Attorney's Docket No.: 07326-002003

Amendments to the Drawings:

Page 1 of 2
MODULAR COMPUTER SYSTEM
Scott Lochner et al.
09/994,520
07326-002003
ANNOTATED SHEET

FIG. 3

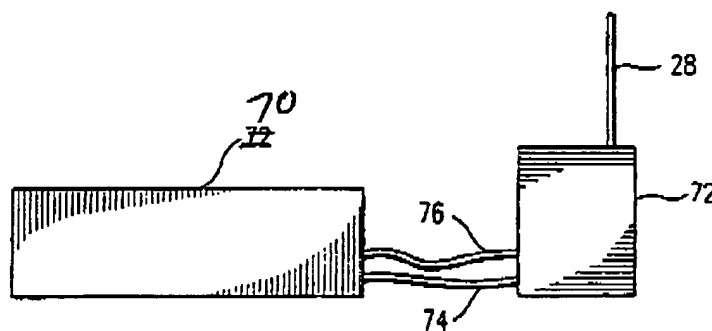
Figure 3 has been amended to properly recite the unit 70.

FIG. 2

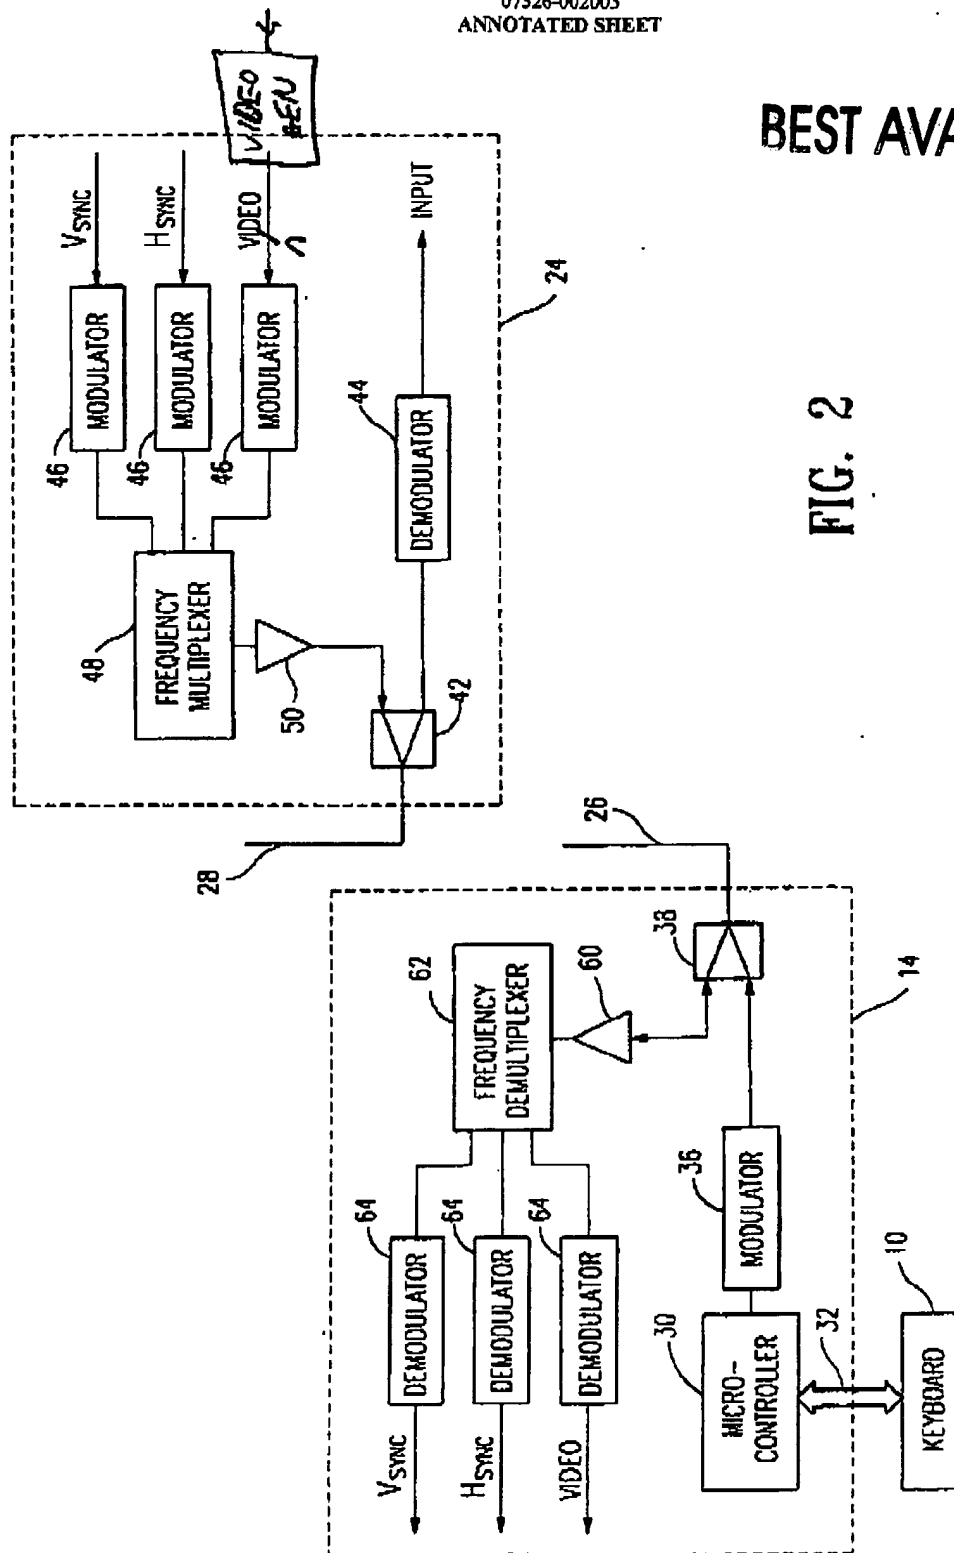
Figure 2 has been amended to add the video generation unit, and a notation that the video represents "n bits".

The drawings stand objected to under Rule 1.83(a). The video generation unit, and a notation that the video represents "n bits", has been added to Figure 2. Figure 3 has been amended to properly show the "unit 70".
